Service Bulletin

Bulletin No.: 24-NA-003

Subject: Sunroof Wind / Air Deflector Inoperative

Brand:	Model:	Model Year:		VIN:		Engine:	Transmission:
		from	to	from	to		
Buick	Enclave	2017	2024	-	-	All	All
Chevrolet	Traverse						
GMC	Acadia

4242149

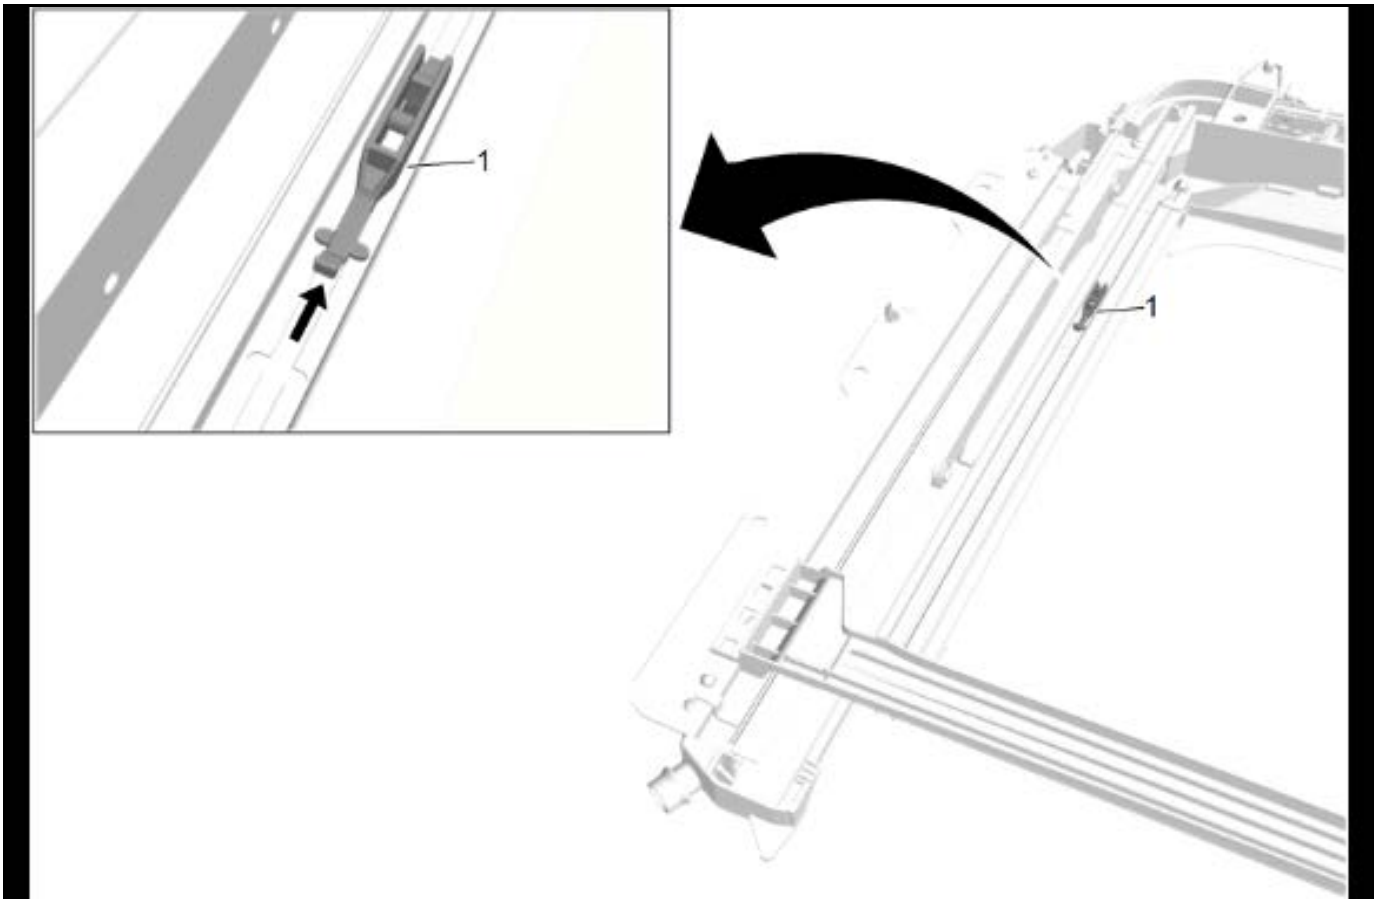
Involved Region or Country	North America, Middle East, Israel, Palestine, Chili, Columbia, Peru, China - SGM
Additional Options (RPOs)	Equipped with ROOF-SUN, GLASS, SLIDING, ELEC, TRANSPARENT GLASS FIXED (RPO C3U, LFY)
Condition	Some customers may comment on the wind / air deflector coming unsecured and or not allowing the sunroof to operate as intended.
Cause	The cause of the condition may be due to the clip securing the wind / air deflector has come unsecured and/or broken.
Correction	Replace the clips and secure the deflector as needed.

2. Using a suitable tool, push the sunroof air deflector (2) down and back to release it from the sunroof housing assembly clips (1).

3. Pull the sunroof air deflector (2) upward and back to remove.

4. Place the new pre-soaked sunroof air deflector clips (1) into the sunroof housing rails, and gently slide them back until the wings are fully seated into the rail cutouts (2).
